September 29, 2021

Re: Tetra Tech Peer Review Letter 2
Red Robin Pastures
Dover, Massachusetts

FRONT ENTRY OPTION (N.T.S.)

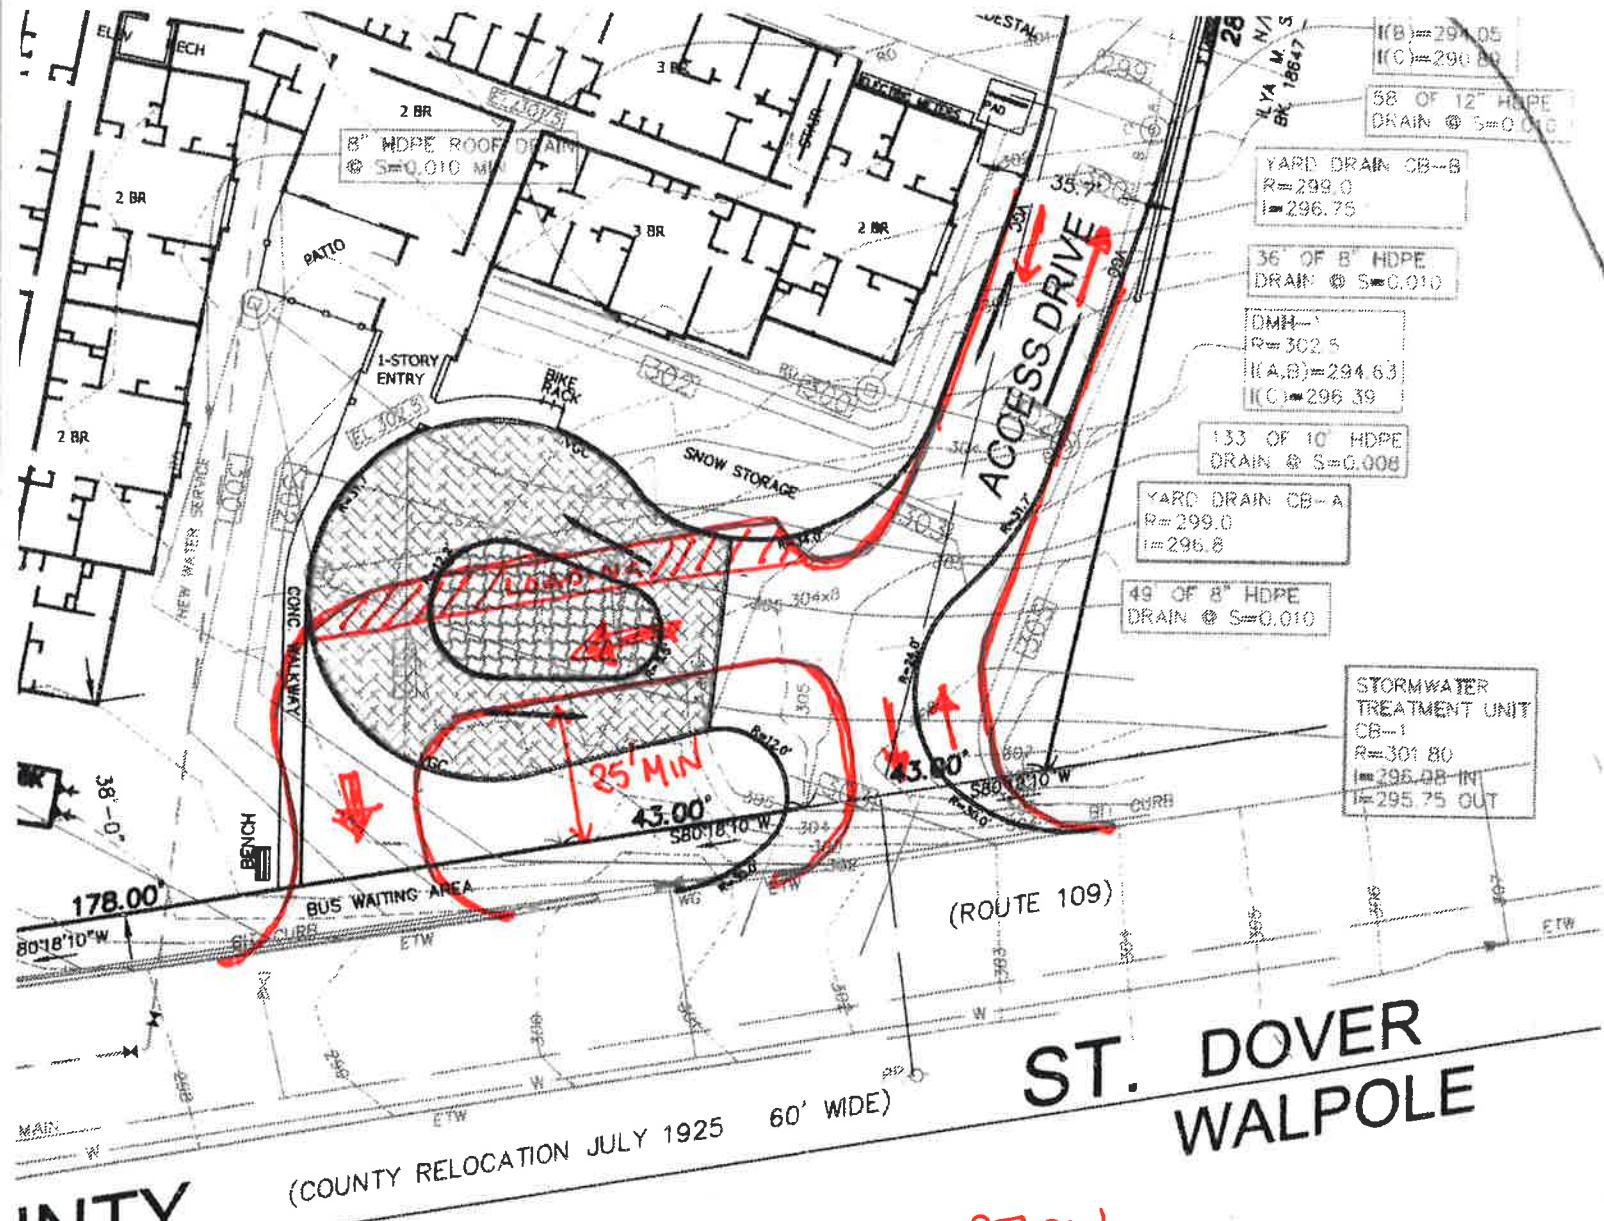
53. Main entry turnaround face of curb appears to be within several inches of the proposed vestibule column creating an almost certainty that it will be hit by circulating traffic or damaged during snow removal. Recommend resolution of conflict including consideration of an alternate access geometry. The proposed front entry and circle, although workable, is a bit awkward and inefficient. We recommend the applicant consider a “u-shaped” front access that provides a secondary means of access and better circulation. See attached sketch.
